# CHARTER TOWNSHIP OF VAN BUREN PLANNING COMMISSION AGENDA Wednesday, October 27, 2021 – 7:30 PM REMOTE MEETING –AGENDA

### ITEM # 1 Case 21-033 – DTE Energy / 42061 Ecorse Road Rezoning Request

ITEM # 2 Case 21-029 – Subaru / 50255 Michigan Avenue Preliminary and Final

ITEM #3: CASE 21-028 – Kojaian / 6615 Haggerty Road Preliminary Site Plan Review

CONSTRUCTION PLAN

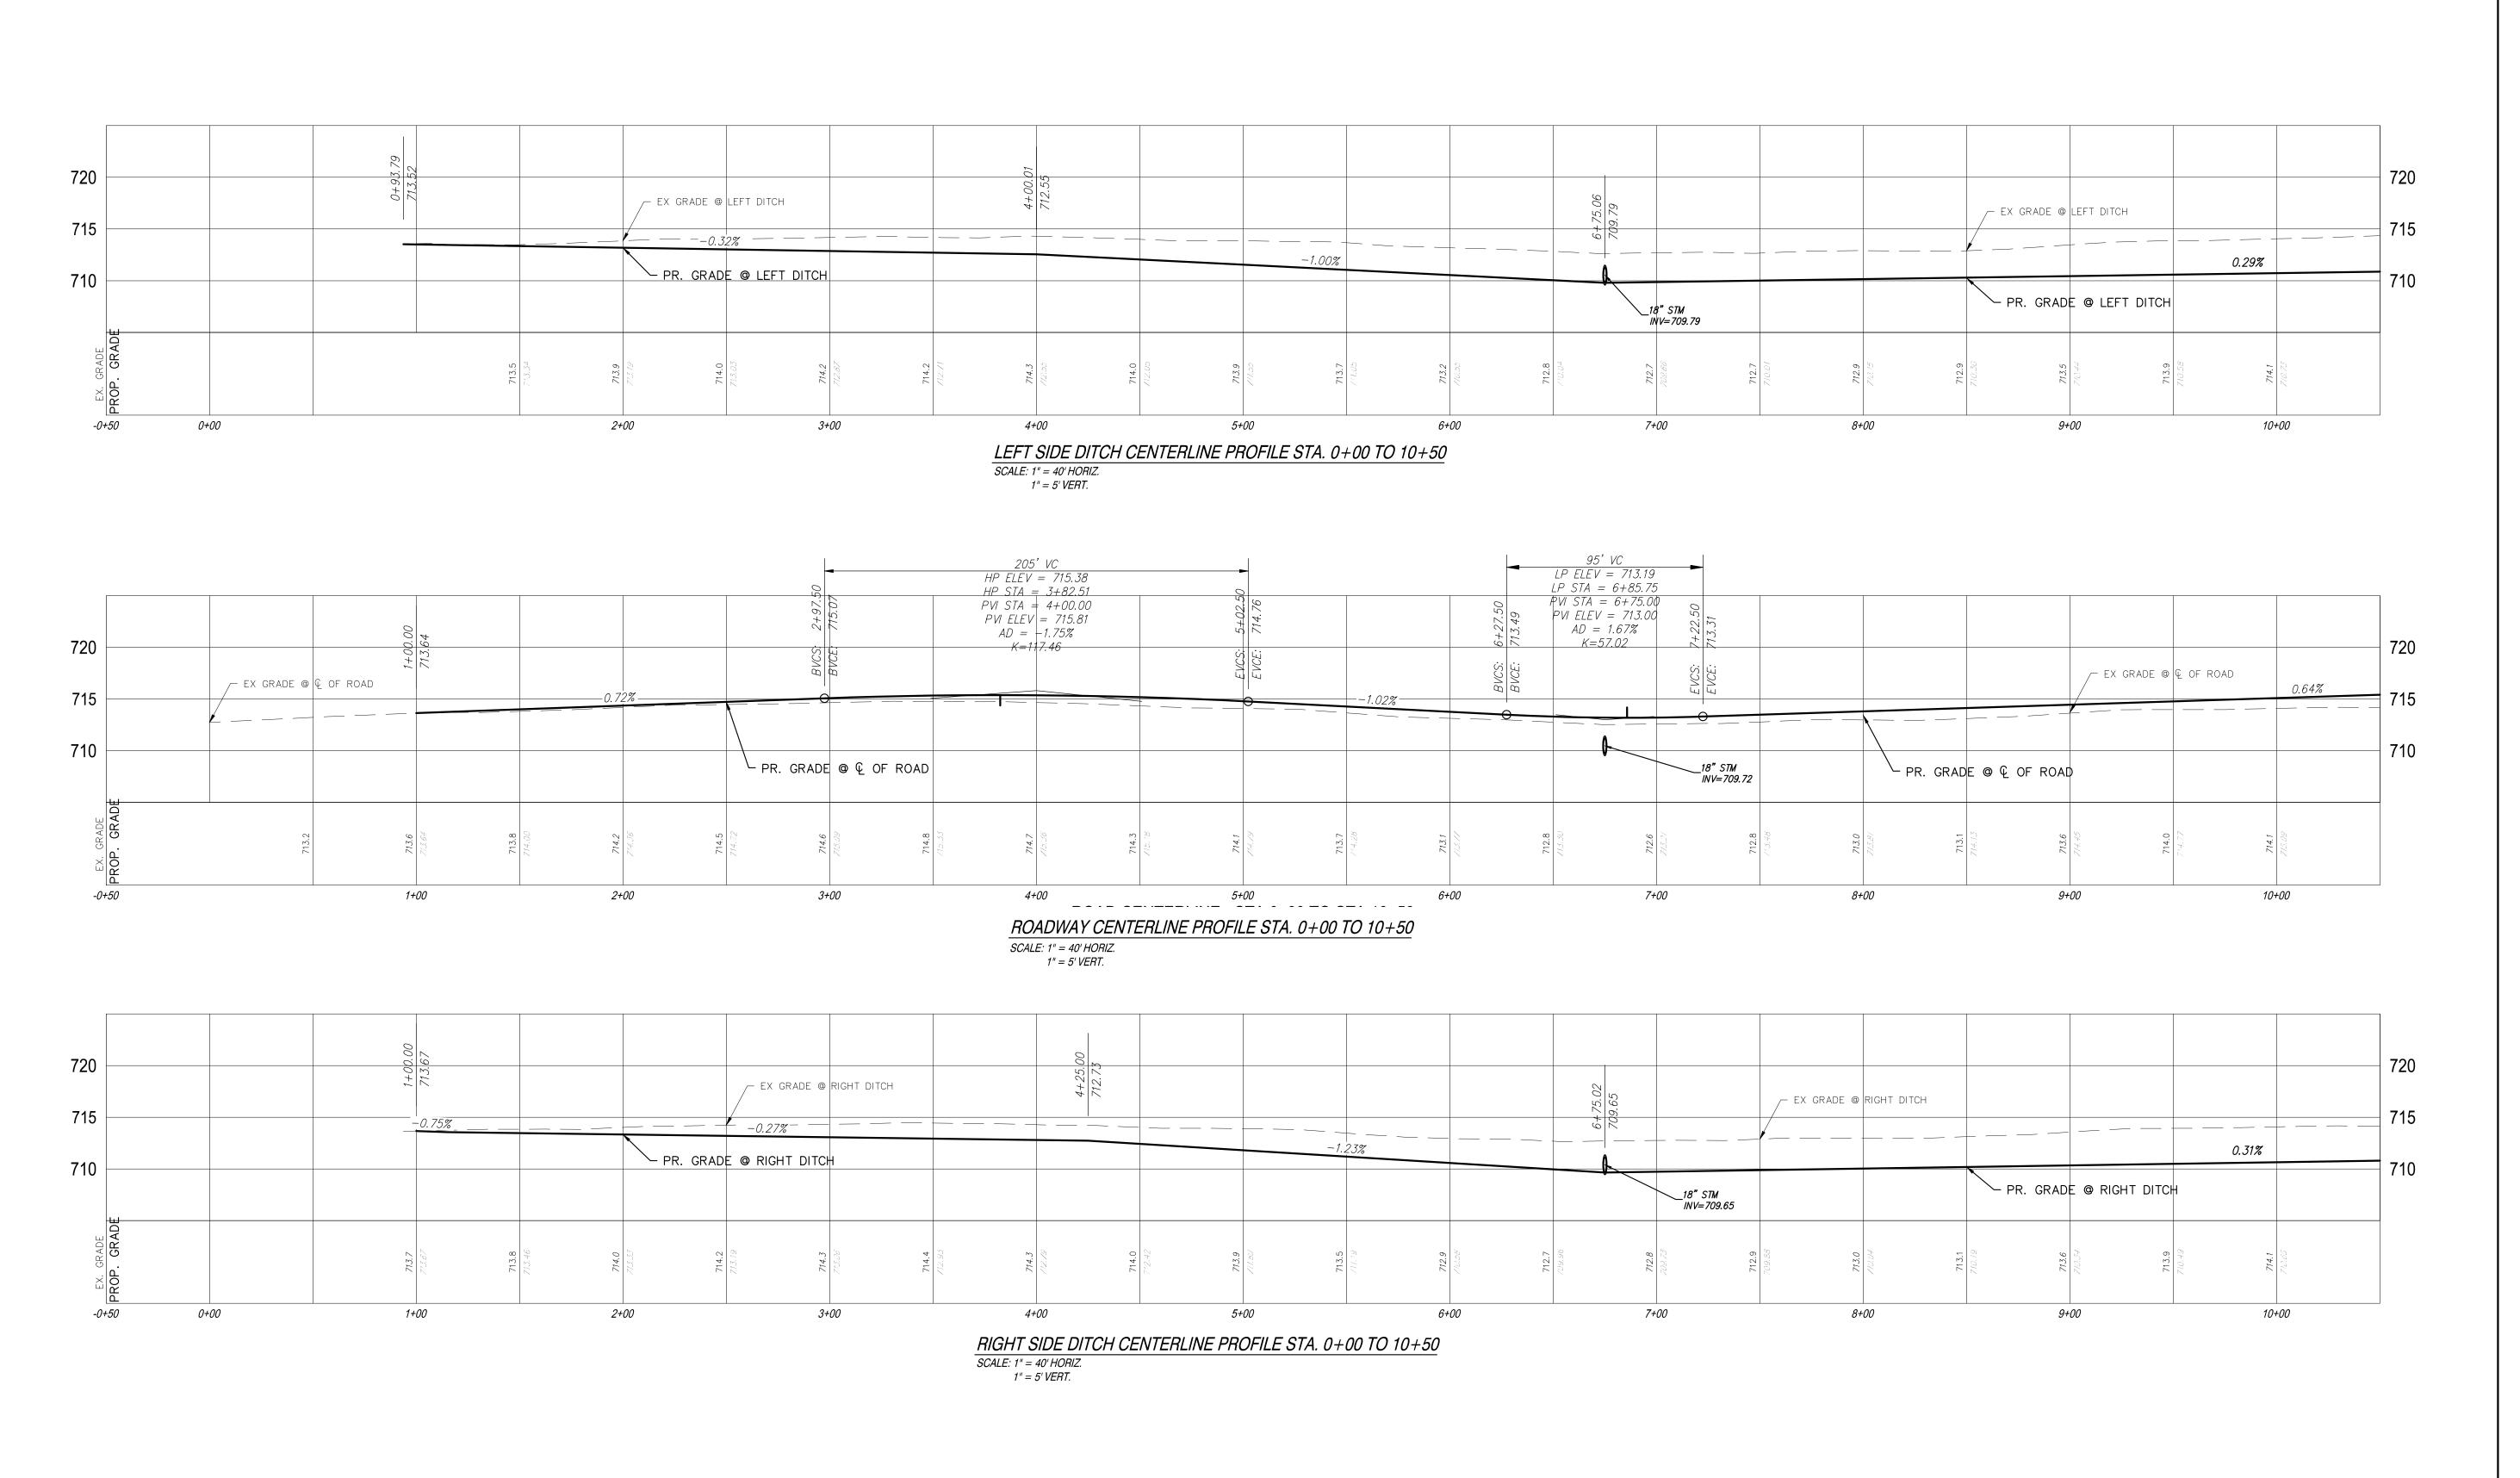
- 9. Lighting. Per sheet C4.1 the test track will operate 9 am 5pm. Headlight testing will occur from dawn till 10 pm. The applicant has clarified that no additional site lighting will be added as part of this project.

SCALE: SHEET NO. C5.2

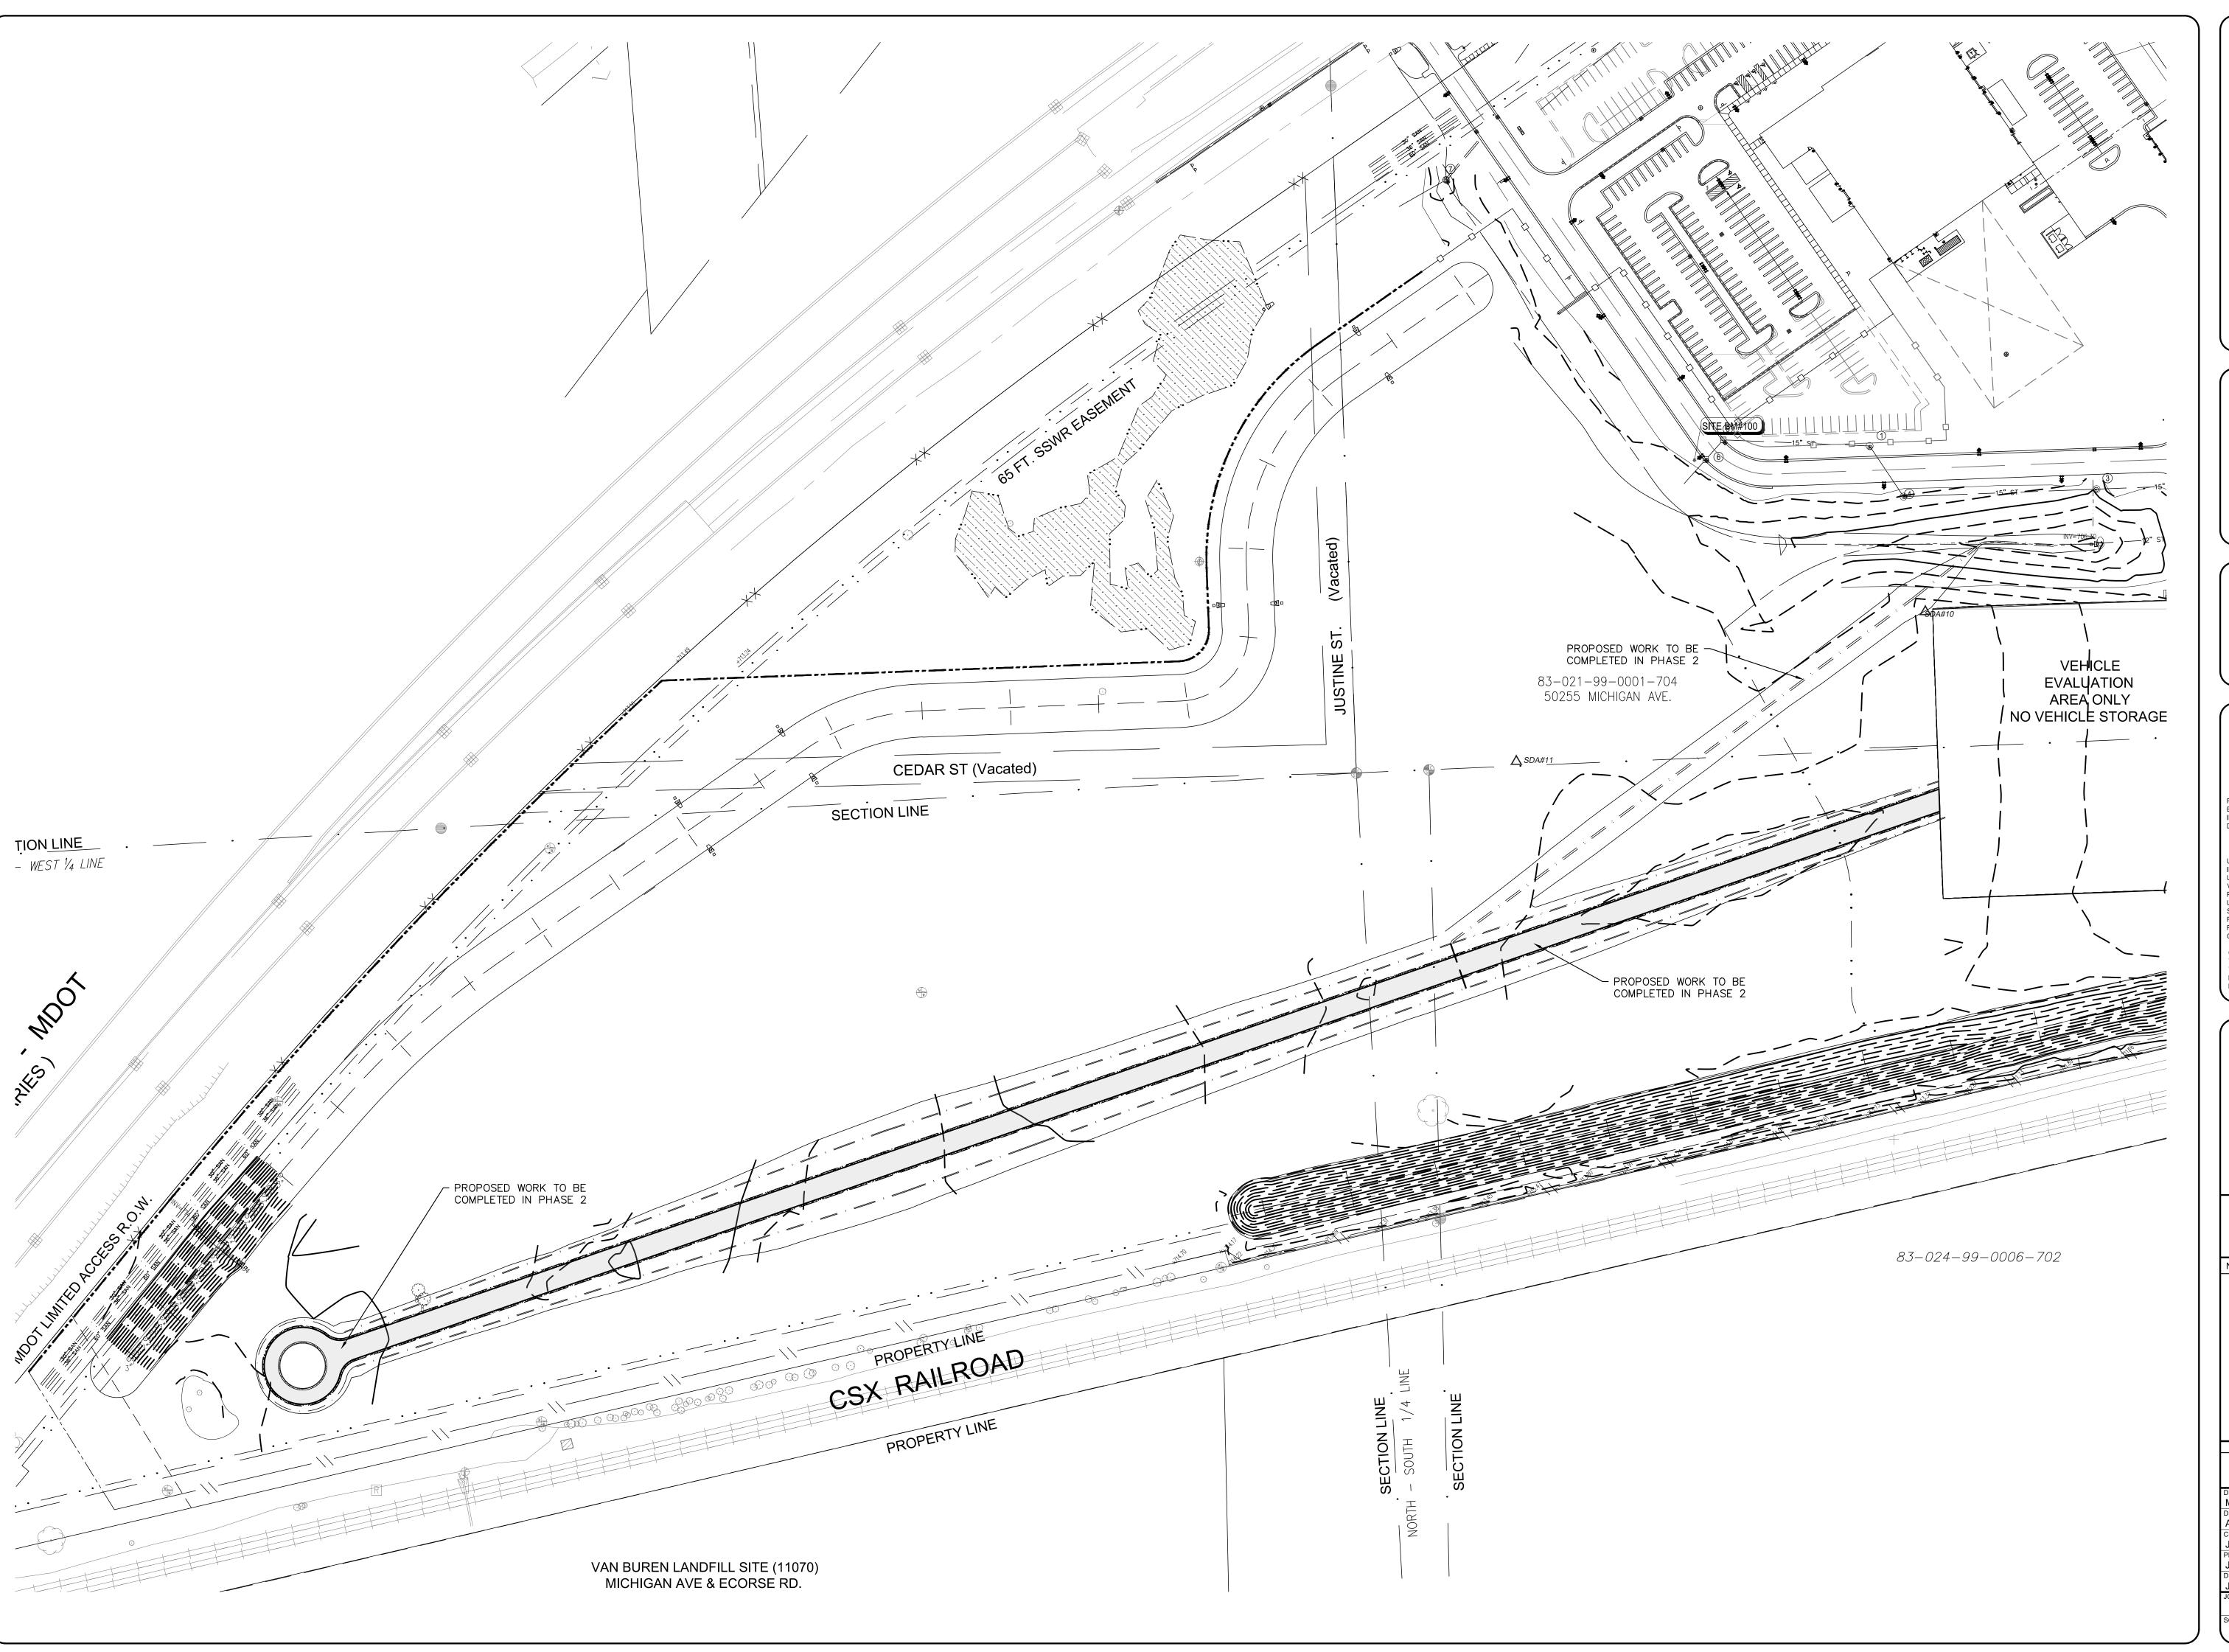
- 3. The proposed drainage area shown on C5.1 show changes in the drainage sub-area boundaries outside of the proposed limits of work. Applicant must clarify this discrepancy. See Below:
